## RESPONSE TO REQUEST FOR ADDITIONAL INFORMATION

### APR1400 Design Certification

Docket No. 52-046

RAI No.: 357-8344  
SRP Section: 06.02.04 - Containment Isolation System  
Application Section: Section 6.2.4  
Date of RAI Issue: 01/05/2016

Figure 9.2.2-1 Component Cooling Water System Flow Diagram (4 of 4)

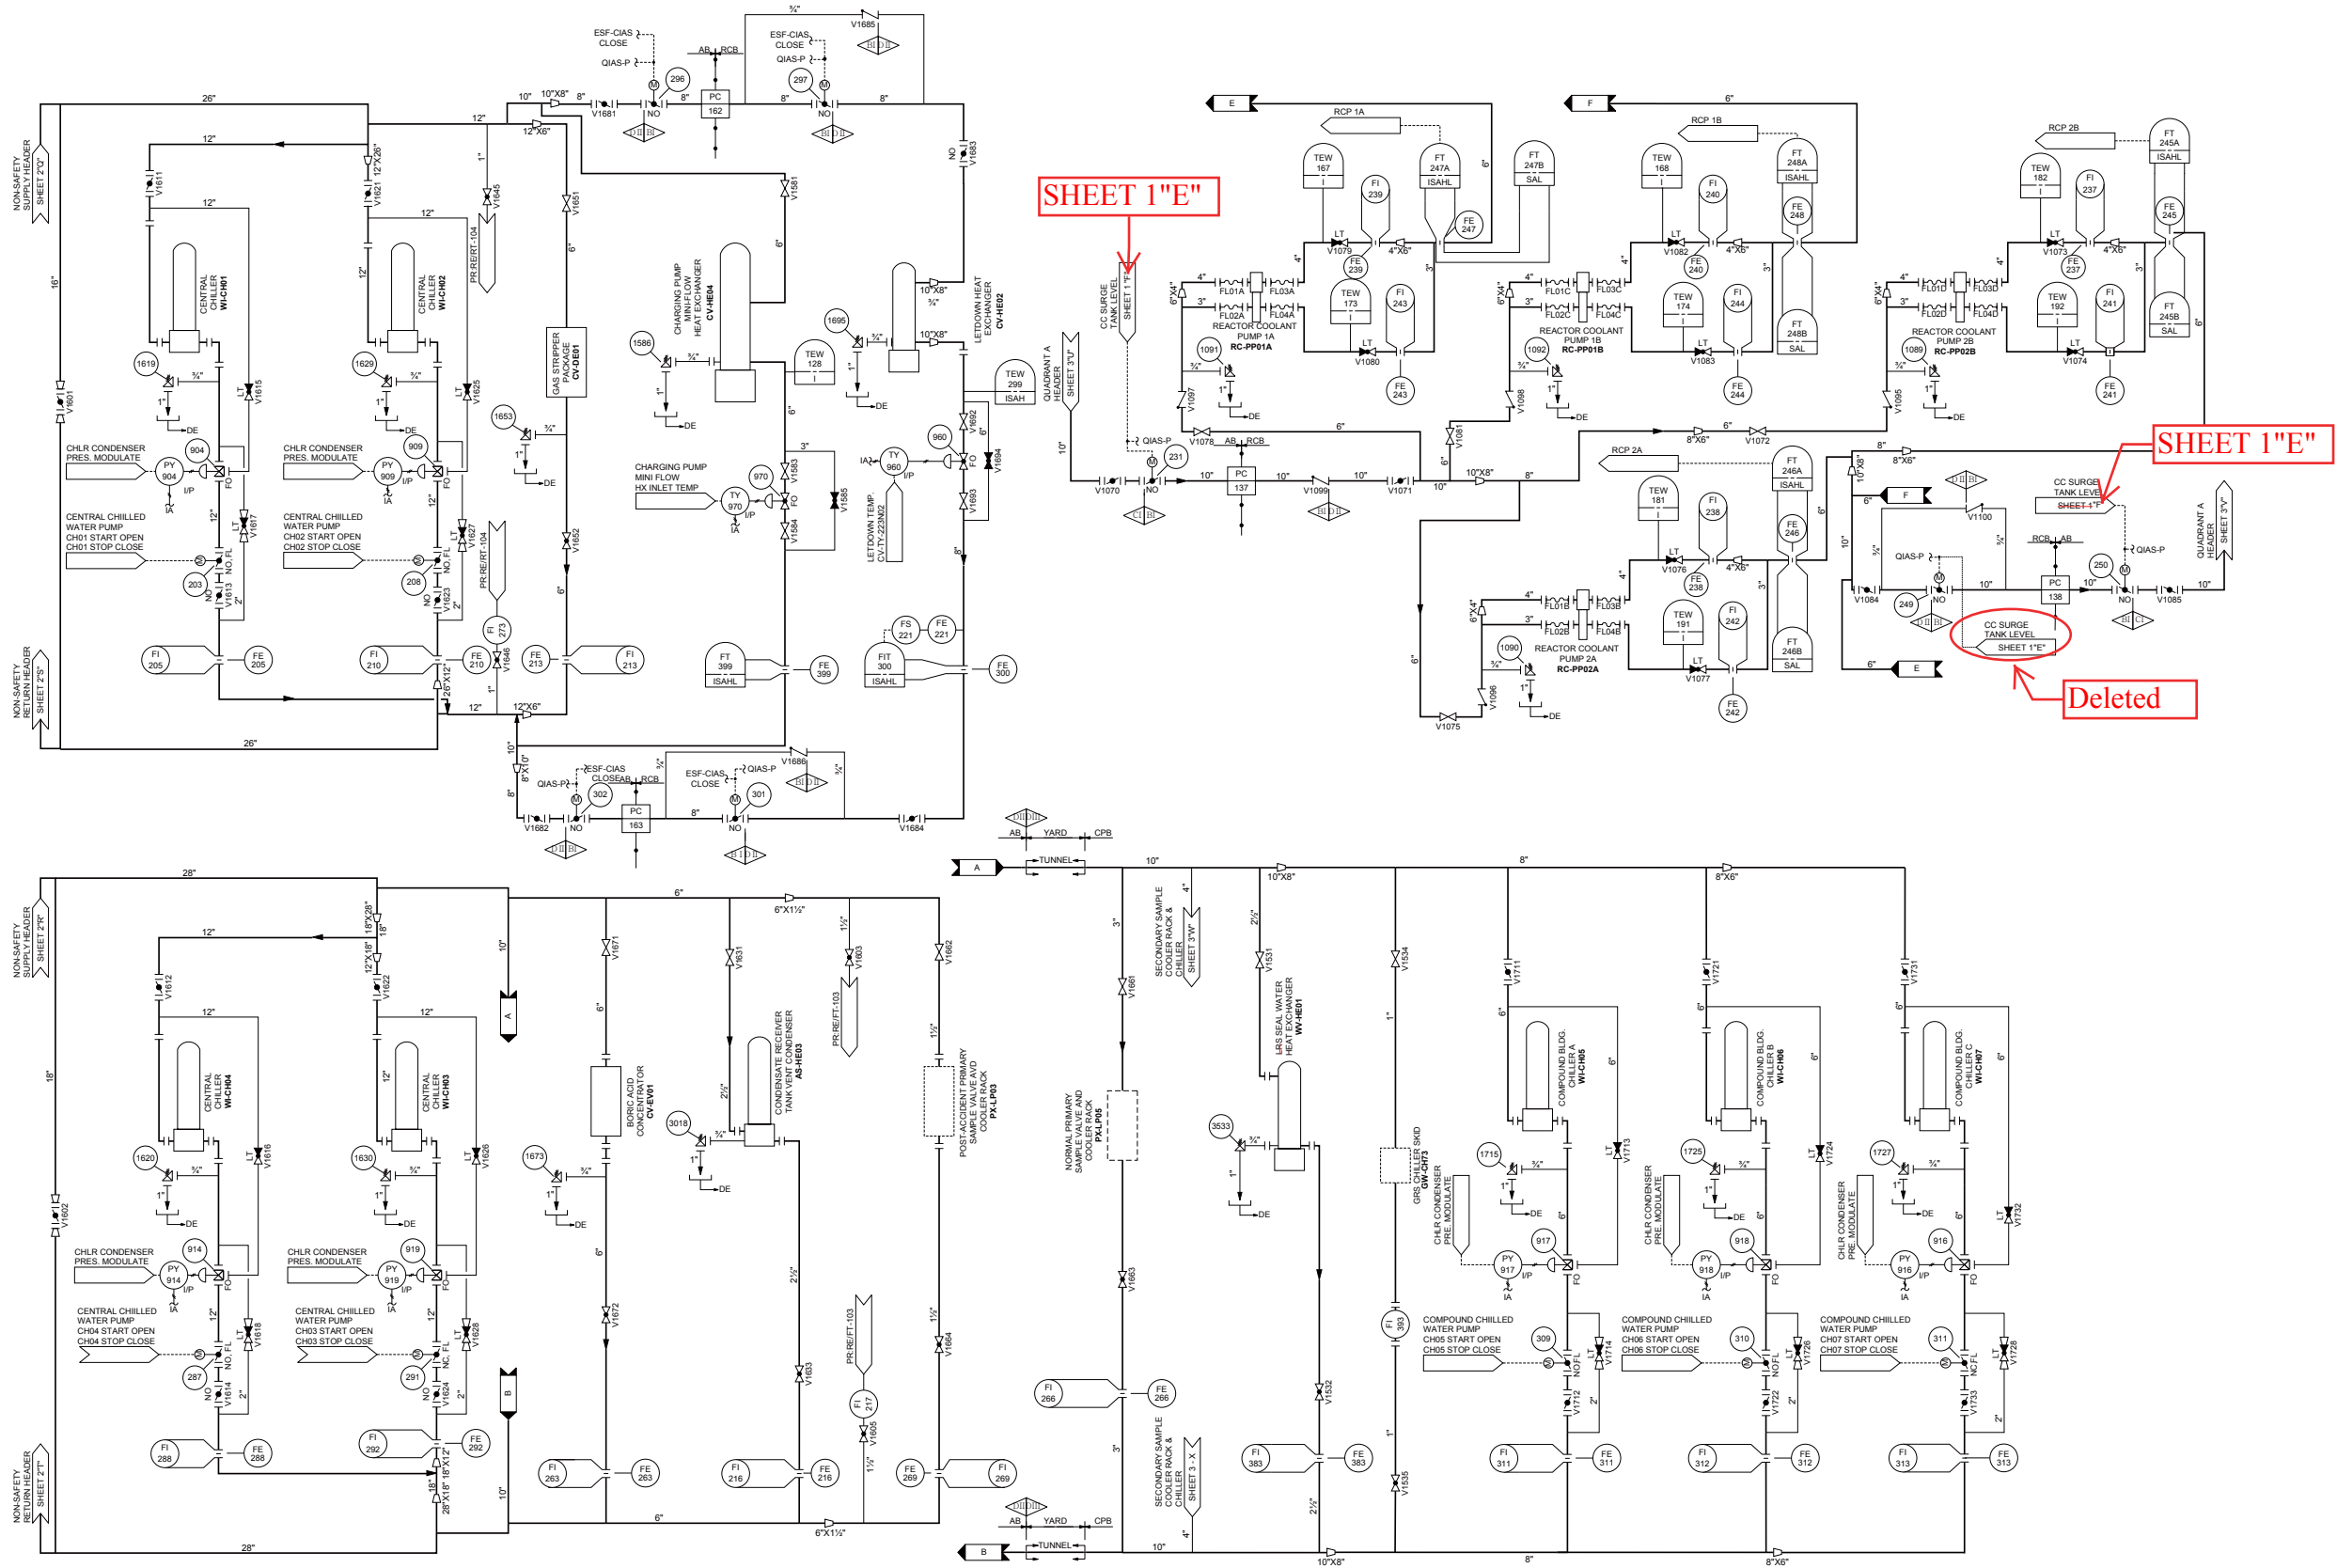
Clarify if all power operated containment isolation valves (CIVs) have position indication in the main control room (MCR) and have station blackout (SBO) considerations for indication and closure.

Pursuant to the RG 1.141 and ANSI N271-1976, Section 4.2.3 guidance, provide a description in the DCD that states that all power operated isolation valves have position indication in the MCR. In addition, pursuant to RG 1.155 Section C.3.2.7, indicate in the DCD if provisions are provided, independent of the preferred and blacked out unit's onsite emergency ac power supplies, for valve position indication and closure for containment isolation valves that may be in the open position at the onset of a SBO.

In addition, Table 9.2.2-6 and Figure 9.2.2-1 will be revised to correct the power segregation for Valves CC-231, 249, and 250.

DCD Tier 2, Subsections 6.2.4.1.2, Table 9.2.2-6, and Figure 9.2.2-1 will be revised, as indicated in the Attachment associated with this response.
